# Service Bulletin - June 2023

## SAF Tire Pilot Plus™ (TPP) Inflation System

### Tire Pilot Plus Safety Concern

**Figure 4**

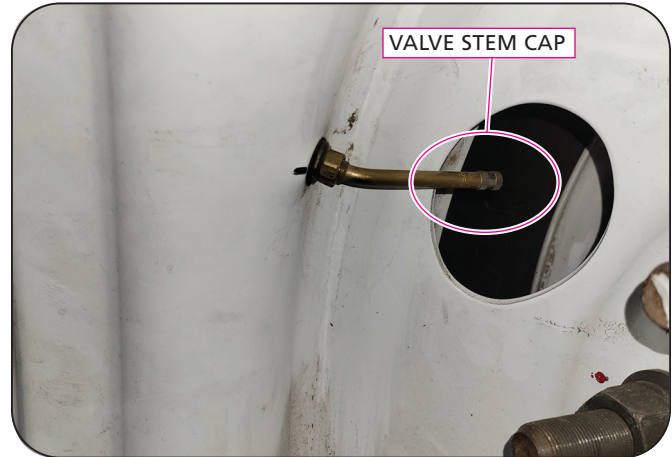
1. If determined to have an electronic regulator assembly, isolate the trailer air tank from its air supply. Drain the air from the trailer air tank.
2. Loosen and remove the tire hoses by hand starting at the hubcap fitting (**Figure 2**). Tire hoses should be disposed.
3. Remove the tire hose fitting from the hubcap using a 15mm or 9/16" deep well socket. (**Figure 3**).
4. Install a valve stem cap on the tire valve stem (**Figure 4**).
5. Install the 1/4 NPT pipe plug in the hubcaps. Install hand tight plus 2 turns or 25-30 lb-in (**Figure 5**).
6. Disconnect the air line from the PPV as illustrated (**Figure 6**).
